FSN Ref: 2025-FSN-000103

URGENT Field Safety Notice
Risk of Automated Impella Controller (AIC) not detecting an Impella pump when it is connected.

1. Information on Affected Devices*	
1.	1. Device Type(s)*
	All Automated Impella Controller (AIC)
1.	2. Commercial name(s)*
	Automated Impella Controller (AIC)

Image 1: AIC Screen during console-to-console transfer

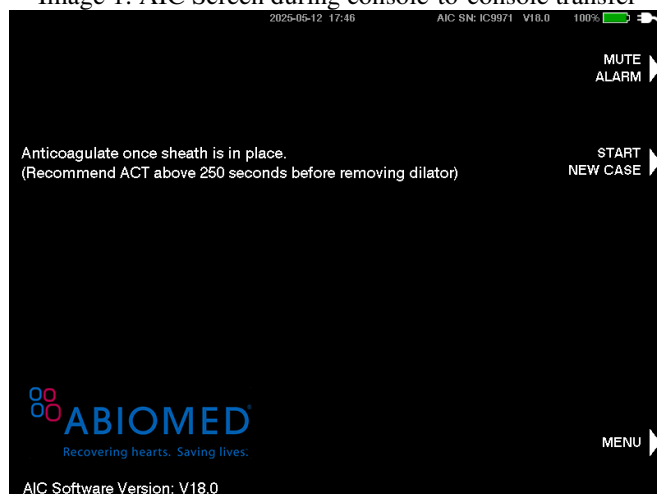
During console-to-console transfer, if the pump is not detected once connected to the AIC, the AIC screen in Image 1 remains and does not advance.

If the AIC screen in Image 1 remains for more than 20 seconds and does not advance after connecting the pump to the transferred console:

- Immediately switch the pump to the previous console to restore support to the patient.
- If the previous console displays an alarm message, switch to a different console if available.
- Restart the console that does not advance from Image 1 before attempting to re-connect a pump.

Image 2: AIC Screen during case start up

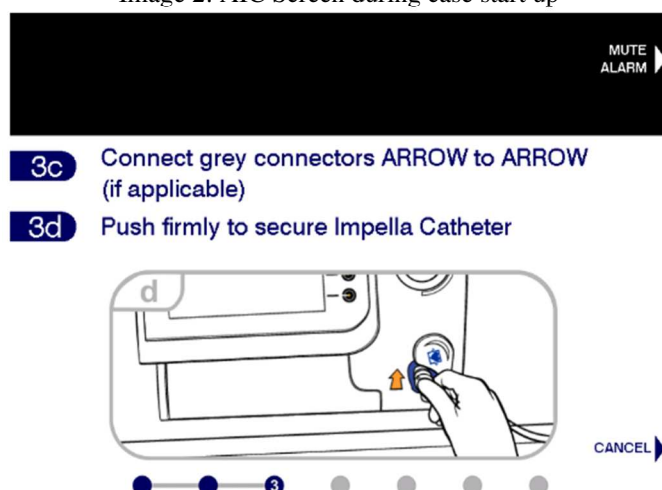
During case start, if the pump is not detected once connected to the AIC, the AIC screen in Image 2 remains and does not advance.

If the AIC screen in Image 2 remains for more than 20 seconds after connecting the pump and does not progress to indicate "Detecting Impella", either re-start the case on the console or switch the pump to a different console.
